Access Compliance Report

Public Rights-of-Way

(Curb Ramps)

Intersection ID: 23929	Main Street: BROADWATER_LN	Cross Street: STEPHENDALE_DR	Location: NE
ADA ID: 74F91AAB1D2C	Ramp Type: PerpDiag	Initial Pass/Fail: Fail	Overall Compliance: No
Severity Score: 30			
Codes/Mitigation Info/Possible Solution		Field Measurements/Component Compliance

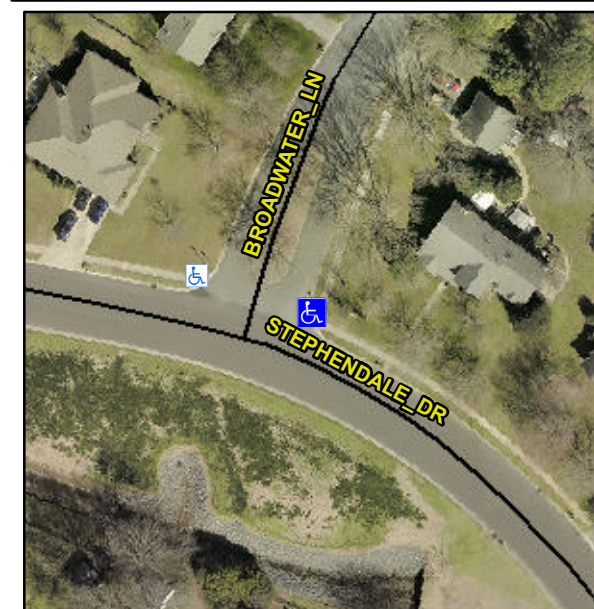
Not Found, R304.5.1, R304.2.2

Compliance	Description	Data	Compliance	Description	Data
N/A	Ramp Length (in)	59.0	No	Ramp Slope (%)	10.3
No	Ramp Width (in)	34.0	Yes	Ramp XSlope (%)	0.4
N/A	Flare Type LT	N/A	N/A	Flare Type RT	N/A
N/A	Flare Slope LT (%)	N/A	N/A	Flare Slope RT (%)	N/A
N/A	Flare Traversable LT?	N/A	N/A	Flare Traversable RT?	N/A
N/A	Landing Length (in)	N/A	N/A	DWS Provided?	N/A
N/A	Landing Width (in)	N/A	N/A	DWS Contrast?	N/A
N/A	Landing Slope (%)	N/A	N/A	DWS Length (in)	N/A
N/A	Landing X Slope (%)	N/A	N/A	DWS Full Width?	N/A
N/A	Landing Curb? (Y/N)	N/A	N/A	DWS Offset (in)	N/A
N/A	Shared Landing?	N/A			
N/A	Gutter Ponding?	N/A	N/A	Gutter Slope (%)	N/A
N/A	Gutter Lip Ht (in)	N/A	N/A	Gutter X Slope (%)	N/A
N/A	Painted X Walk1?	No	N/A	Painted X Walk2?	No
	X Walk 1 Direction	To NW		X Walk 2 Direction	To SW
N/A	X Walk 1 Width (in)	N/A	N/A	X Walk 2 Width (in)	N/A
	X Walk 1 Slope (%)	1.6		X Walk 2 Slope (%)	3.4
	X Walk 1 X Slope (%)	1.6		X Walk 2 X Slope (%)	2.0

Remove & Replace Curb Ramp With Two New Directional Ramps or Equivalent.
